Village of Arlington Heights
Conceptual Plan Review Committee
Community Room, 3rd Floor
Arlington Heights Village Hall, 33 S. Arlington Heights Rd.
June 14, 2023
6:30 PM

Item: Pride Gas Station - 3460 W. Euclid Ave. - T1790

VILLAGE OF ARLINGTON HEIGHTS **STAFF DEVELOPMENT** **COMMITTEE REPORT**

Temp File Number: T1790
Project Title: Pride of Arlington Heights
Address: 3460 W. Euclid Ave.
PIN: 02-26-201-020

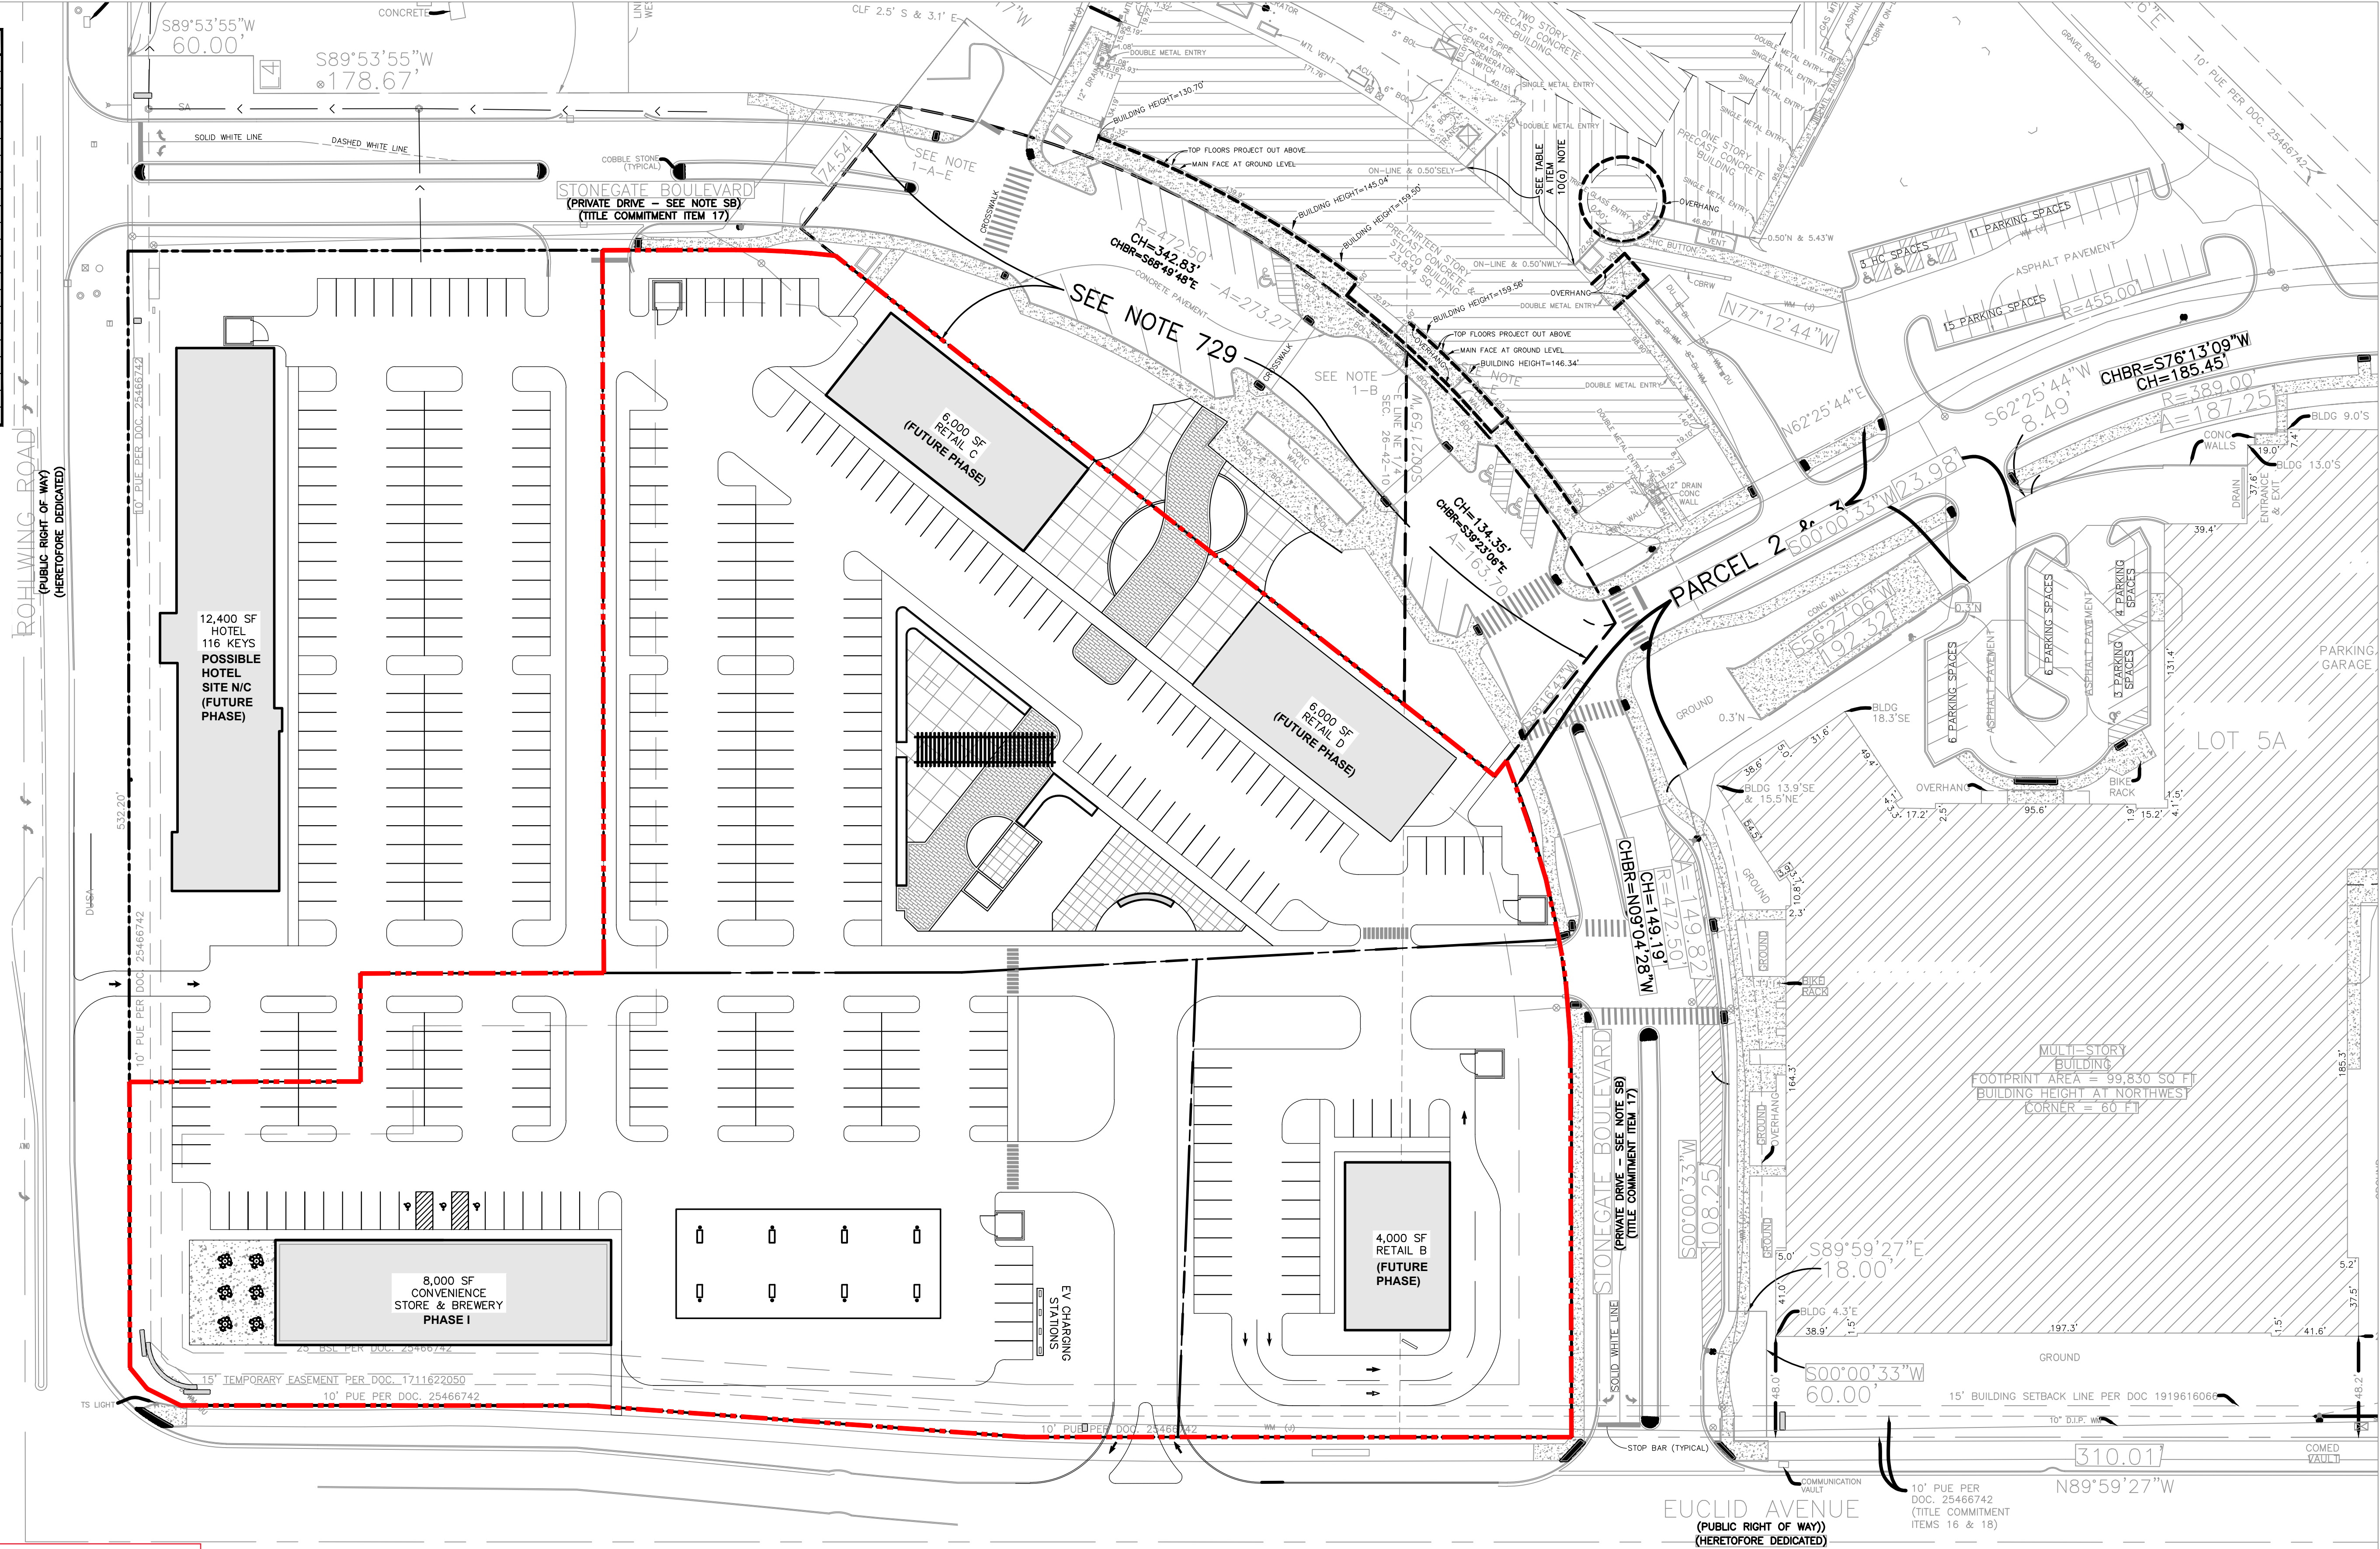
We have reviewed the submitted conceptual plans for the Pride Gas Station proposed at the northeast corner of Euclid Avenue and Rohlwing Road. A similar concept for a Pride Gas Station at this location was reviewed earlier by the Village in March, and preliminary feedback provided at that time was that the Village does not support this use at this location. The Staff Development Committee (SDC) has reviewed this proposal and has the following comments:

- The proposal is not permitted by the approved plan for the Arlington Downs Planned Unit Development (PUD).
- The proposed site reconfiguration is not harmonious with the intent of the Arlington Downs PUD to create a walkable, mixed-use development for adjacent residential properties.

- The revised site plan for the commercial zone is poorly laid out, and the hotel is in an unacceptable location as it inhibits good traffic circulation on site.
